# Service Bulletin

## PRELIMINARY INFORMATION

**Subject:** Rough Harsh Ride

**Models:** 2015 Cadillac Escalade Models  
2015 Chevrolet Tahoe LTZ, Suburban LTZ  
2015 GMC Yukon Denali Models  
With Magnetic Ride Control Suspension (RPO Z95)  
Vehicles Built Before 2/10/2015

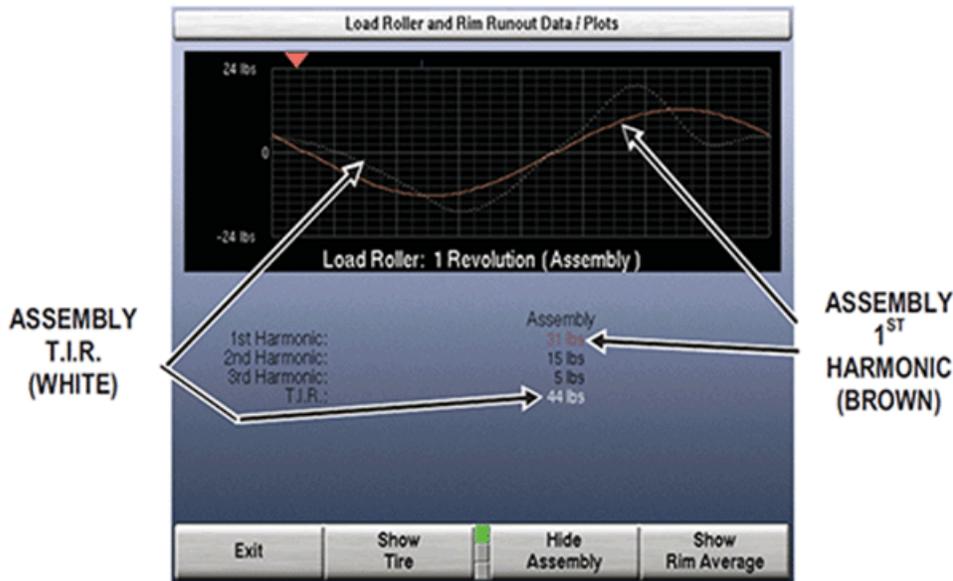
Ensure tire and wheel assemblies are not contributing to the issue. Keep in mind this rough ride issue will often show up as T2 in response to road input, (suspension reacting to road input, rather than absorbing it). If T1 is present, or any higher order, other than some T2 in direct-response to road input, expansion joints, etc. the tire and wheel assemblies must be investigated. There have been some cases of T2 tire issues, some high-speed RFV issues (primarily with the 22-inch Bridgestone tires), and some cases of tire/wheel assemblies showing acceptable RFV numbers, but with further investigation, have been found to have bent inboard rim flanges with hidden tire damage, visible inside when dismounted.

The GSP9700 checks tire low-speed RFV only, in the radial plane only

The GSP9700 is set to display T1 RFV. Higher order RFV, T2 & T3 can be displayed in the Assembly Data Plots Screen, as shown above. Depending on the level of GSP9700, the screen may be under 'Data' or 'Runout Plots,' then "Rim and Load Roller Runout Plots."

When checking tires on the GSP9700, if (radial) T2 is high or close to the (radial) T1 value, the tire should be replaced. As an example, if a tire and wheel assembly is measuring T1 at 10 lbs RFV, the tire would be considered good; however, if in displaying the higher orders, it is found that the tire and wheel assembly also has T2 at say 9 lbs RFV, the tire needs to be replaced. Refer to the latest version of PI1354 for latest procedures.

Road Force Variation (RFV) Specification to Address Ride Concerns	
P-Metric Tires on Light Trucks, SUVs	15 lbs (6.8 kg) or Less
NOTE: Arrange the tires on the vehicle in the following order: lowest RFV at LF, next RF, next LR, highest RR
